# UNITED STATES PATENT AND TRADEMARK OFFICE

10/705,899

## DETAILED ACTION

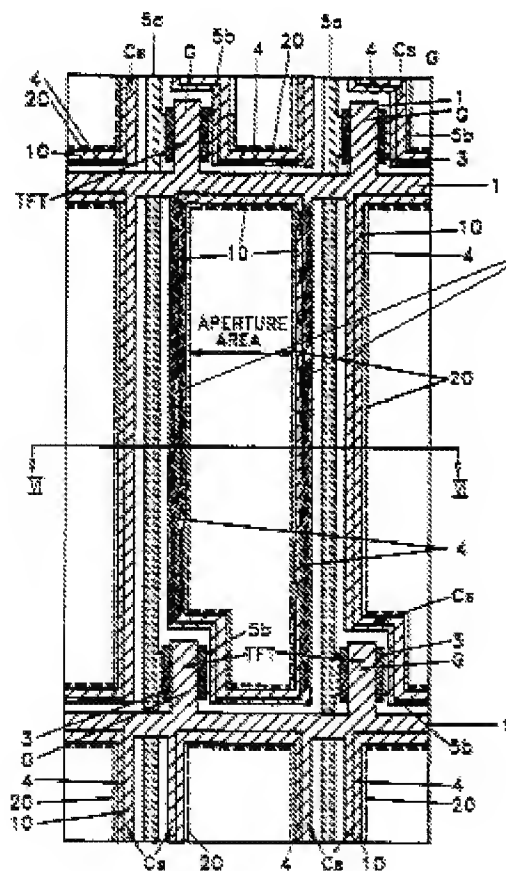
In regard to claim 1, Kim et al. disclose (Figs. 3G-J) a multi-domain liquid crystal display device comprising:

- a plurality of data lines 5a for applying a data signal on the first substrate;
- a plurality of gate lines 1 for applying a gate signal, the gate lines crossing the data lines to define a plurality of pixel regions,
- a thin film transistor near each crossing of the gate lines and the data lines;
- a common electrode 17 on the second substrate;
- a pixel electrode 13 connected to a drain electrode of the thin film transistor in each pixel region; and
- an auxiliary electrode line 10 electrically connected to at least one of the common lines in each pixel region,

the auxiliary electrode line connects to gate line and takes advantage of the gate signal applied to the gate lines would cause the disturbance of liquid crystal molecules because the auxiliary electrode may distort an electric field applied between the common electrode and the pixel electrode to generate a fine domain at right above the auxiliary electrode

- the auxiliary electrode line is formed between the pixel electrode and the data line at an outside of the pixel electrode in the pixel region and the auxiliary electrode is not overlapped with the data line.
- the auxiliary electrode line inherently takes advantage of the gate signal applied to the gate lines.
- the gate line has a larger width than the auxiliary electrode line.

- the auxiliary electrode line is formed in the same layer as the gate lines.
